Service Bulletin

Bulletin No.: 23-NA-142

Subject: No Forward Gear When Shifting from Park to Drive and/or Reverse to Drive

6404322

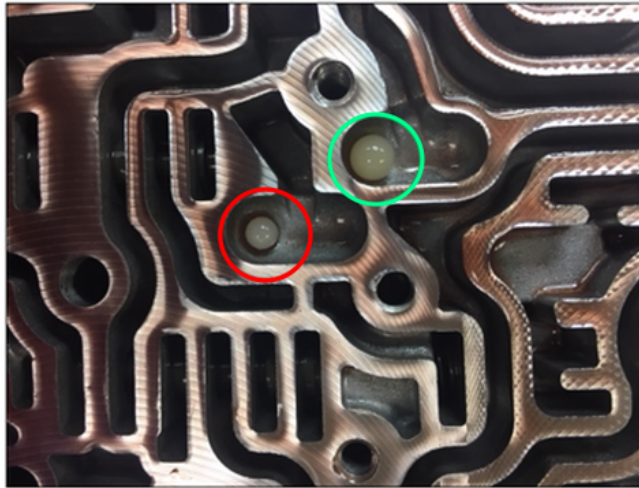
Cause	 <p style="text-align: right;">6404748</p> <p>This condition may be caused by a Spacer Plate in the valve body that does not meet the specification for chamfer across the entire circumference of the coined check ball seat.</p>  <p style="text-align: right;">6404809</p>
--------------	--

- The seat for the check ball is out of spec relative to coin depth. This potentially can cause burrs, dents, or dings, which could cause the plastic check ball to wear prematurely.
- Note:** School buses, some of which shift to Park at each student stop, may exhibit the earliest signs of failure.
- The #1 check ball has a high duty cycle and when combined with the issue, there is a possibility for the check ball to wear and then become stuck or pass through the spacer plate.

- As indicated in the graphic above, the check ball circled in RED has prematurely worn down. It should be the same diameter as the check ball circled in GREEN.

Correction	Replace the spacer plate and check ball.
-------------------	--
